SERVICETEKNOTES

TABLE OF CONTENTS

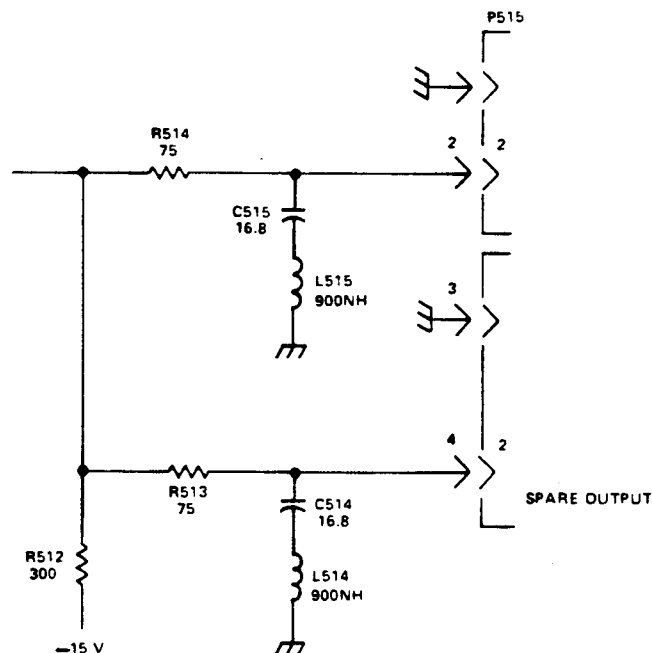
- o L514 (P/N 108-0683-00) was added, "teepee" fashion, in series with C514
- o L515 (P/N 108-0683-00) was added, "teepee" fashion, in series with C515.

The schematic below illustrates the circuit changes.

Figure 1

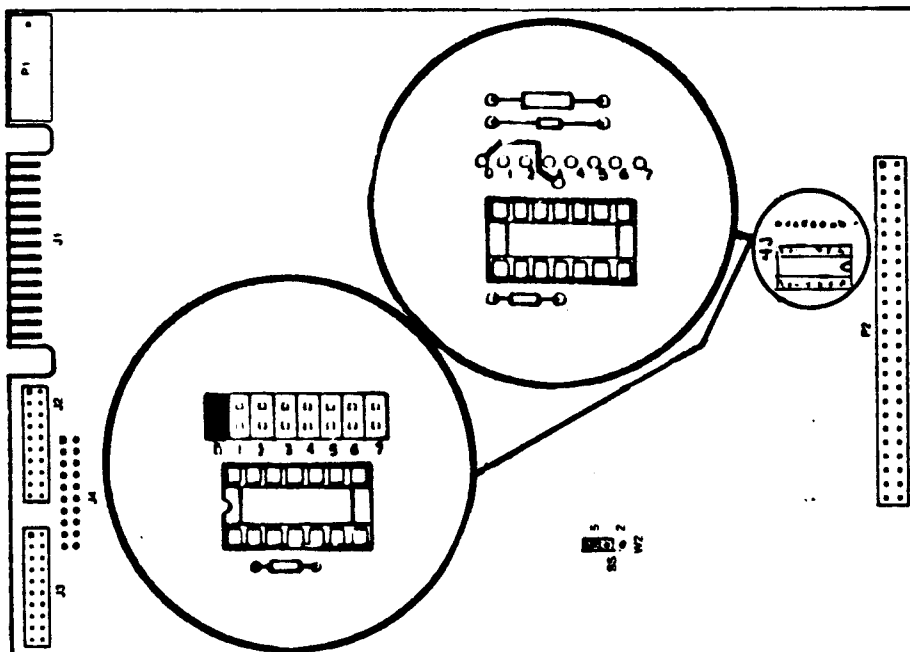
The 670-8437-00 rolled to -01 when the wire jumper at board location 4J, to select a device address, changed to a double row of pins and a moveable jumper, see figure 1. Xebec rolled the board assembly number from 104526 to

Configuring the Winchester controller is a matter of selecting the proper device address. The default device address is zero (0) as shown in the two exploded views on the Winchester controller board, figure 1. However, when connecting multiple devices, each device must be at a different device address. This requires the user to choose the device address. Device address 7 is always reserved for the host controller, such as the MSIB I/F (Option 45).

Sector size should be set for 512 bytes, strap W2 (on the 104526) or W2(on th- 104527) should be set at 5, as shown in Figure 1.

T.V. Pattern Generator Connector

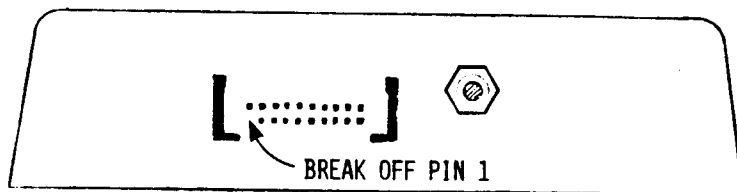
The ribbon cable from the T.V. Pattern Generator is polarized at the 4692 end to prevent reversal. Unfortunately we failed to polarize it at the other end and it can still be reversed, which typically blows two axial lead fuses, F851 and F855 (P/N 159-0090-00), on the 4692 Drive Module.

To prevent this occurrence, you can easily polarize the plug at the test fixture end. Use a needle-nose pliers to "wobble" and break off pin 1 at the test fixture. Insert a plug, P/N 134-0153-00, into pin 1 on the ribbon cable (it is marked with an arrow and is on the red stripe side). See the figure below.

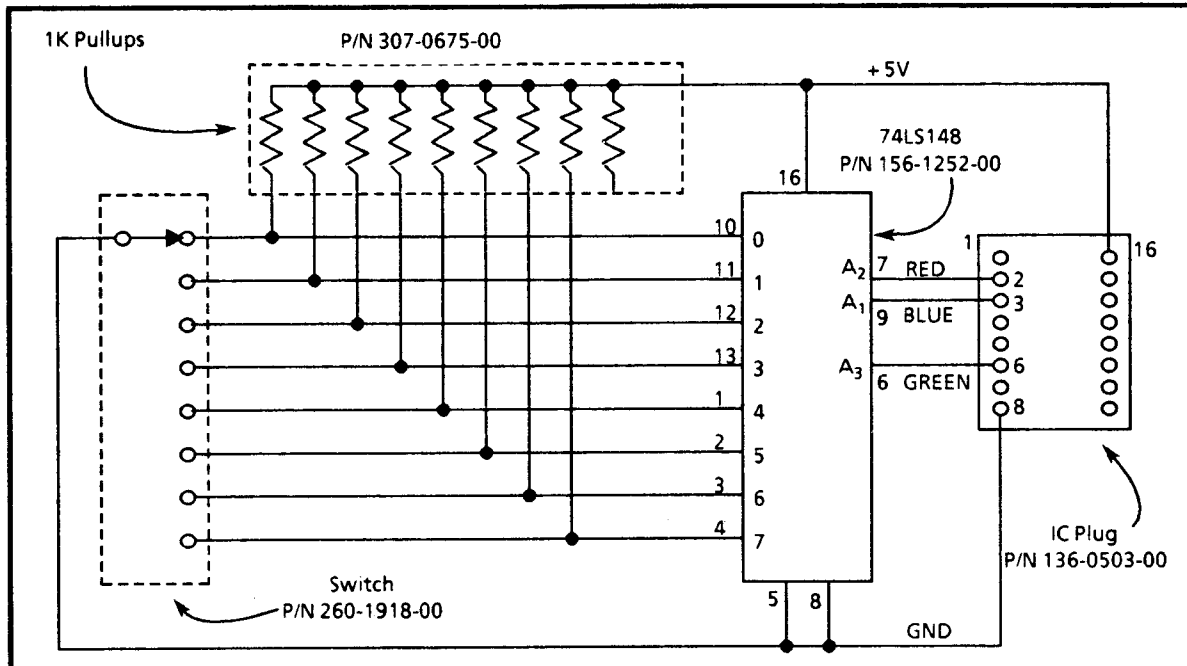
CALIBRATION PROCEDURE**CHANGE Step 16, part a TO READ:**

- a. Remove the Color Bar Logic board (A32) from the TSG7 and lift pin 19 of U172, pins 3 and 11 of U152, and pin 3 of U147. To avoid damage to the ICs, do not bend the IC leads. Insert the ICs into extra sockets, bend the appropriate leads on the socket, and insert IC's & sockets into the sockets on the board. Remove U179 and replace with the plug from the BCD switch box. Replace the Color Bar Logic Board.

A) Schematic Diagram for BCD Color Bar Selection Box

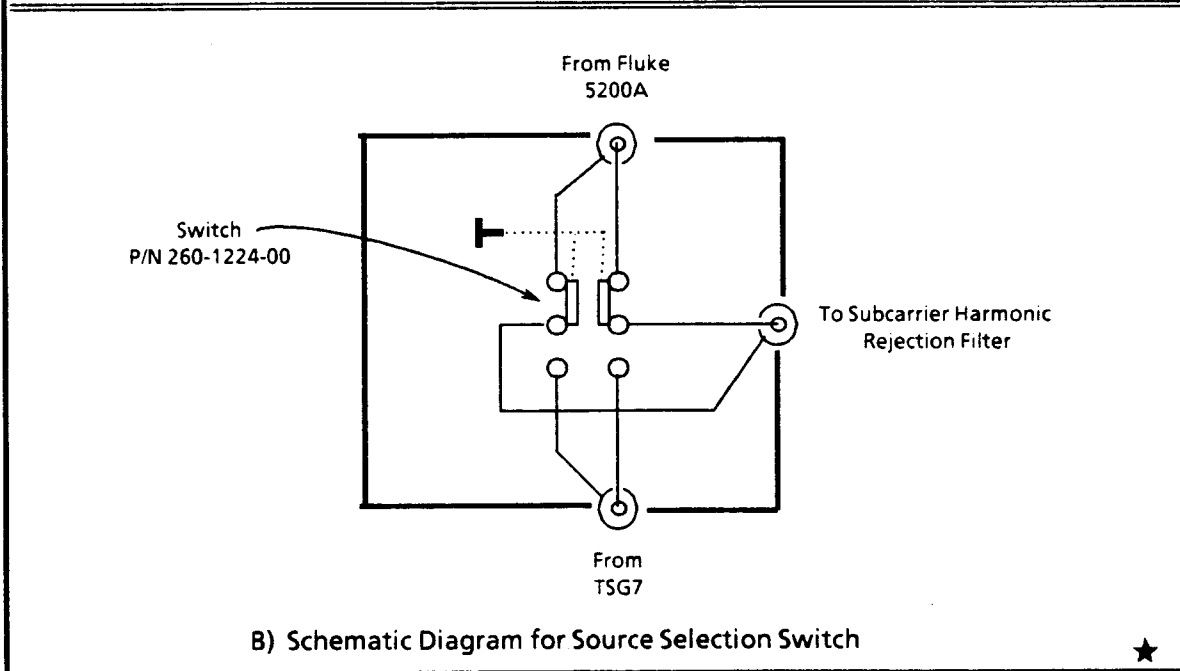
22. Locally constructed source selection switch box.
(See Fig. 1b for schematic and part numbers)

CHANGE Fig. 1 AS FOLLOWS:

Fig. 2. Equipment Connections for Chrominance Amplitude Measurement.

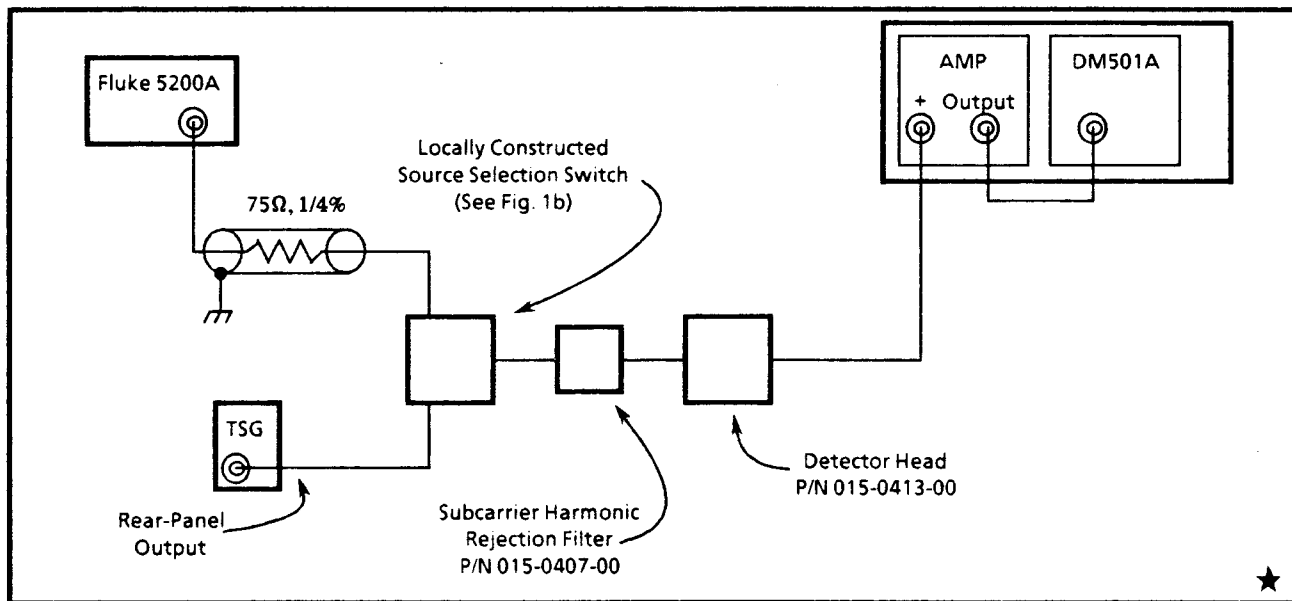
CHANGE Figs. 2 and 3 AS FOLLOWS:
